Docket Number:	21-AFC-02
Project Title:	Willow Rock Energy Storage Center
TN #:	264240
Document Title:	Defenders of Wildlife and California Native Plant Society Comments on Willow Rock Energy Storage Center PSA
Description:	N/A
Filer:	System
Organization:	Defenders of Wildlife and California Native Plant Society
Submitter Role:	Public
Submission Date:	6/14/2025 6:17:33 PM
Docketed Date:	6/16/2025

**DOW and CNPS Comments on Willow Rock Energy Storage Center
PSA Docket No 21-AFC-02**

Re: Willow Rock Energy Storage Center; Docket No. 21-AFC-02

Figure 1: Approximate Vicinity of the Project with ACE Terrestrial Climate Change Resilience Ranks

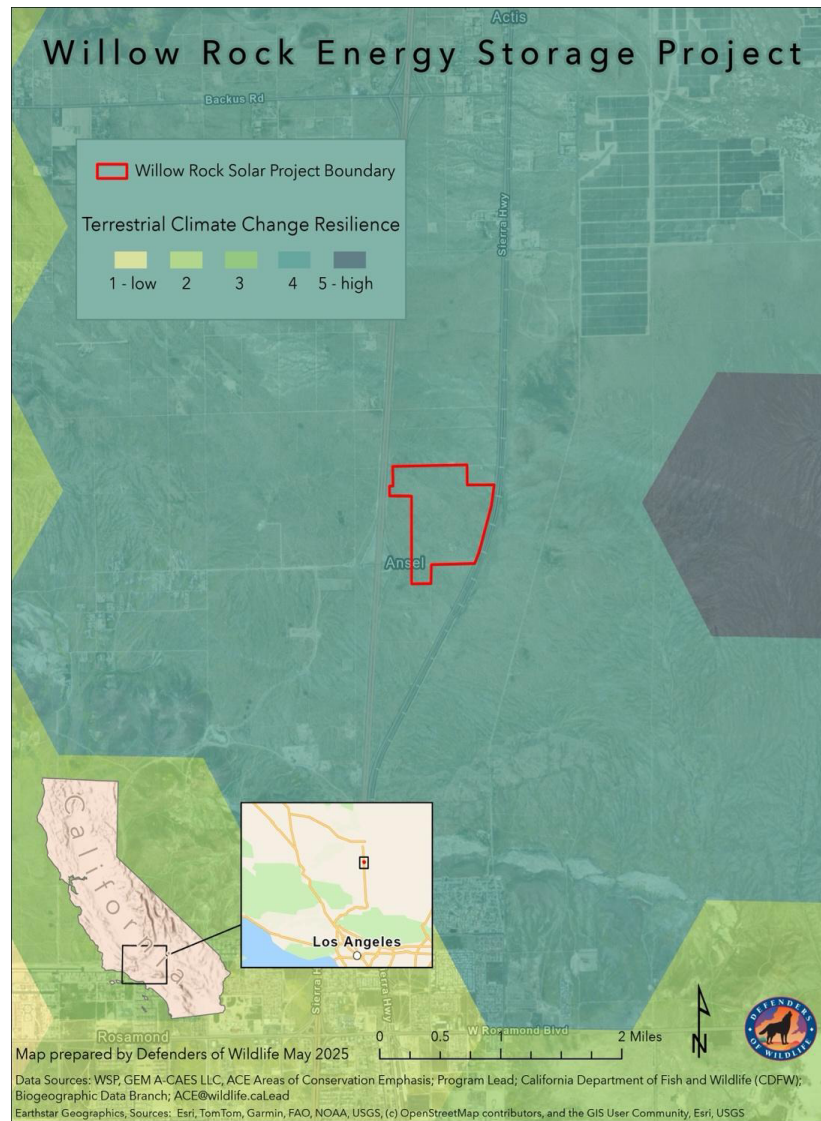
The Project site is identified as an area that may function as a refugia from climate change, as designated by the California Department of Fish and Wildlife (CDFW) Areas of Conservation Emphasis (ACE) project. Terrestrial climate change resilience is one of the main outputs of ACE that examines the probability of a location to function as a climate refugia, where the area is “relatively buffered from the effects of climate change, where conditions will likely remain suitable for the current array of plants and wildlife that reside within a hexagon, and where ecological functions are more likely to remain intact.”¹

The California Energy Commission (CEC) utilizes the ACE climate change data as one of the layers within the 2023 Land-Use Screens for Electric System Planning, a process to revise the land-use screens utilized in state electricity planning processes.² Specifically, Ranks 4 and 5 are used as an exclusion for statewide electric system modeling and resource planning to avoid lands that have a high potential to act as a climate refugia. The Project is located in an area with a 4 ACE Ranking, as depicted below, which is one of the highest scores and therefore should be avoided for renewable energy development.

Development projects should avoid areas that are modeled to act as refugia for climate change. While mitigation is an essential tool for conservation, it is challenging and costly to mitigate the loss of land that serves as a climate refugia when a project is situated in a high ACE ranking area, such as the Project site.

The DEIR acknowledges that several special-status species that have the potential to occur within the Project area are threatened by climate change, including but not limited to Crotch's bumble bee (CBB), desert kit fox, Mohave ground squirrel (MGS) and Swainson's hawk (SWHA). However, it fails to analyze the importance of this area

as a climate change refugia. By not addressing the essential role of this site in mitigating the impacts of climate change and supporting species resilience, the DEIR presents an incomplete assessment of the project’s long-term impacts.
